**UNITED STATES
DEPARTMENT OF THE INTERIOR
FISH AND WILDLIFE SERVICE
Ecological Services**
Suite D, 3530 Pan American Highway, NE
Albuquerque, New Mexico 87107

This report summarizes investigations by the U.S. Fish and Wildlife Service (Service) pertaining to mitigation tree planting for the Corps of Engineers (Corps) project "Cuchillo Dam, Truth or Consequences Unit, Rio Grande Floodway, Sierra County, New Mexico." The Service submitted a Fish and Wildlife Coordination Act Report to the Corps in May, 1986 which included a recommendation to establish four acres of trees to mitigate wildlife impacts of the proposed Cuchillo Dam. The Corps requested the Service develop a detailed plan for the mitigation. In a letter to the Corps dated November 17, 1988 the Service concluded, that as a result of personal studies, cottonwood establishment in the floodpool of Cuchillo Dam was not feasible. This report contains a detailed evaluation of the conditions along Cuchillo Negro Creek relative to tree planting.

Figure 2. Wells in the Proposed Cuchillo Dam Floodpool where Ground Water Table Measurements were Taken.

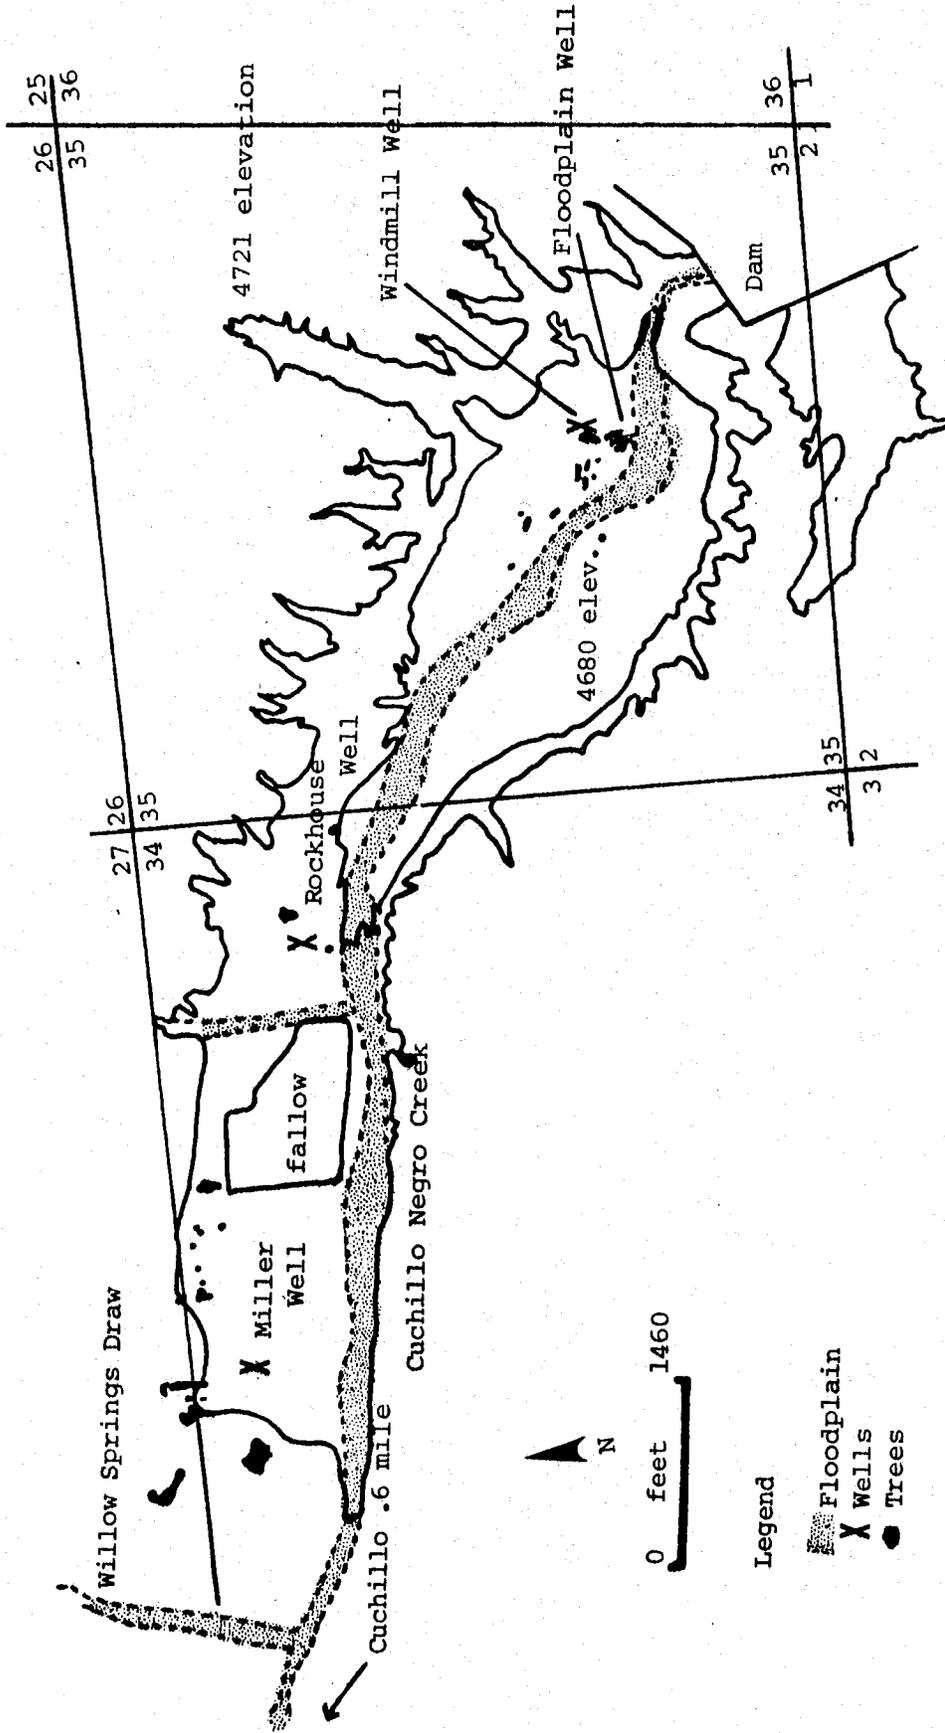
During the growing season (July through September) water depth was measured at four wells (Table 1 and Figure 2). Ground water was deepest at the Miller well, 21 feet, and shallowest at the floodplain well, 1.9 feet. Even though the water table is near the surface at the floodplain well, planting cottonwoods there would not be advisable because flood flows constantly scour the gravel in the area. The only feasible location for trees is on the adjacent land terrace which is about four feet above the floodplain. However, it would be hard to establish trees on the terrace because of the difficulty of obtaining poles over 12 feet long and the problems of digging a hole to the proper depth. Pole planting sites should have a water table that is from 1 to 10 below the surface.

In summary, we recommend against cottonwood pole planting in the Cuchillo Dam floodplain because of the deep water table, scouring and siltation events and the poor success of poles already planted in the area. We suggest the Corps explore alternate vegetation sites or use more drought tolerant trees and shrubs. Areas located in floodplains with a permanent water flow such as the Rio Grande would be desirable. We have contacted the Bureau of Reclamation about planting trees in suitable areas along the Rio Grande upstream of Caballo Reservoir. They have no objection to the Corps using the area for mitigation provided they, the Corps, fund the project. The Plant Materials Center, located at Los Lunas, New Mexico should be able to provide the Corps with more suitable trees and shrubs for the Cuchillo area.

Figure 3. Elevation Contours of the Proposed Cuchillo Dam, Upper Portion, Downstream of Cuchillo, New Mexico.

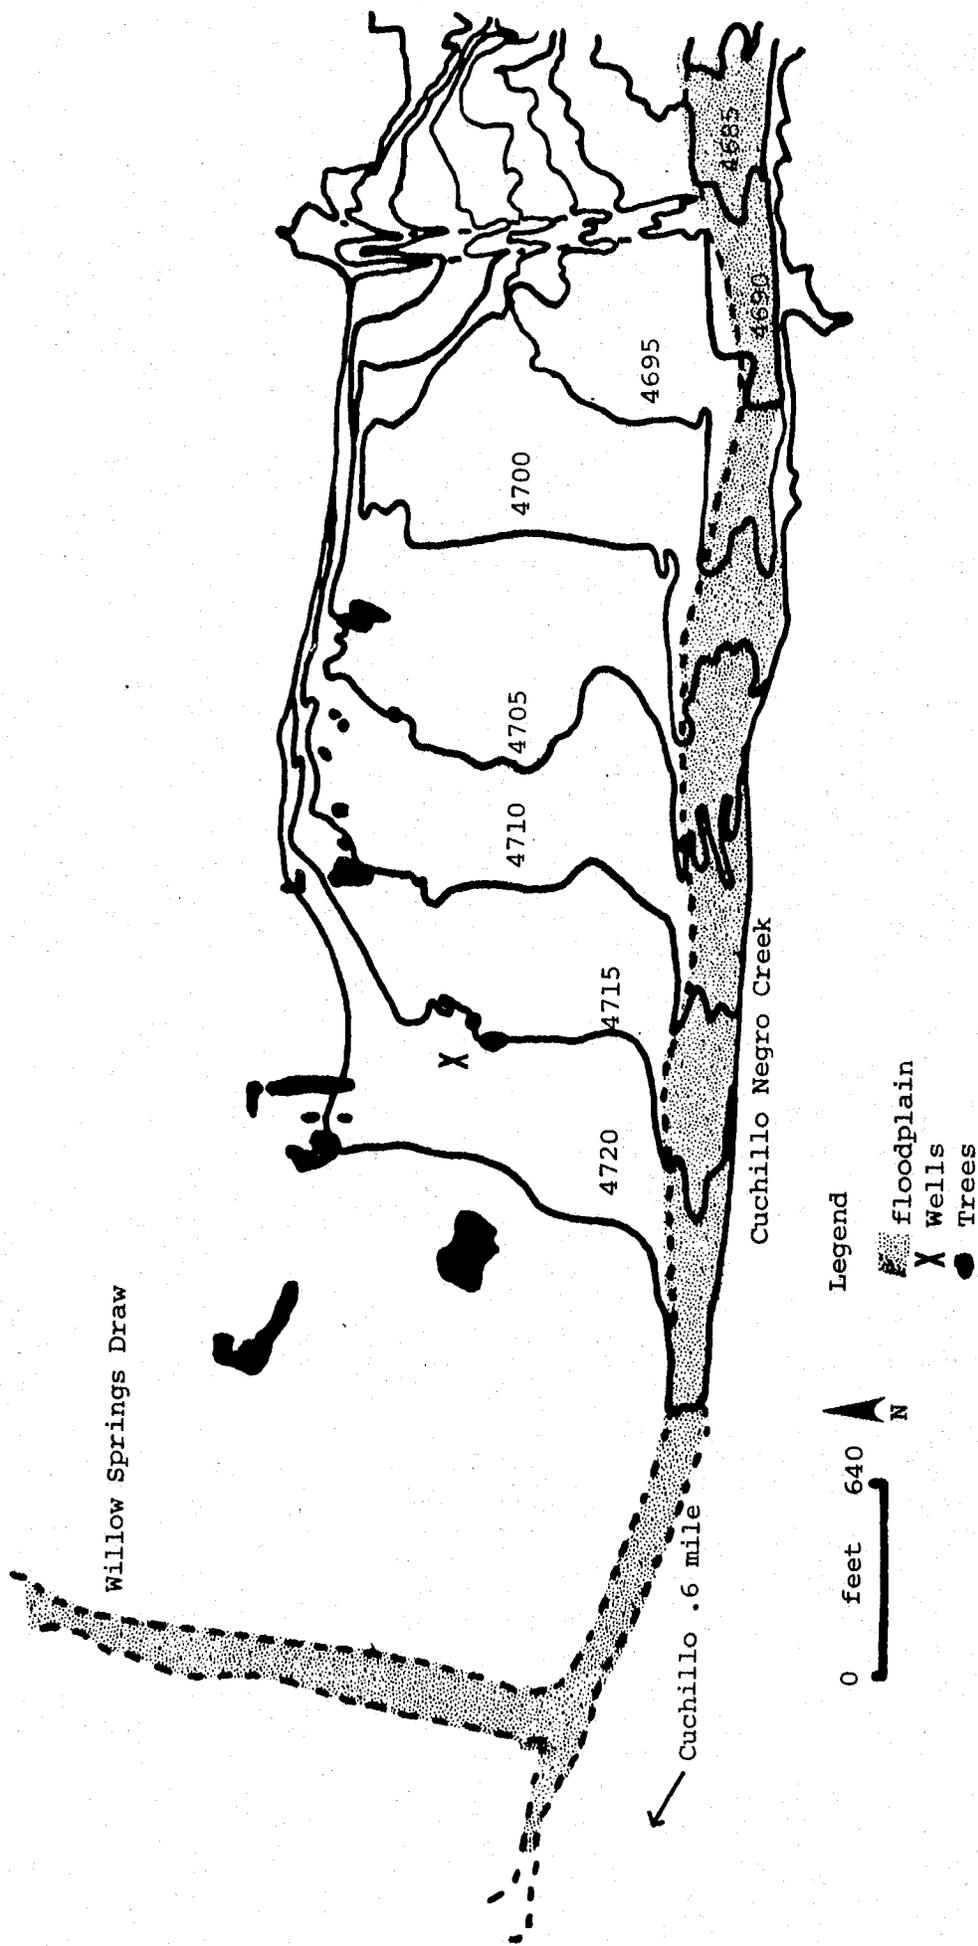
Elevation contours of the proposed floodpool area are presented in Figures 3 and 4. The ground water is deepest at the upper end of the floodpool area and shallowest near the damsite. Even if trees could become established in the shallowest ground water areas, flood flows may scour them out or bury them in silt. The Corps has predicted over the 100 year life of the dam that 63 feet of silt will be deposited.
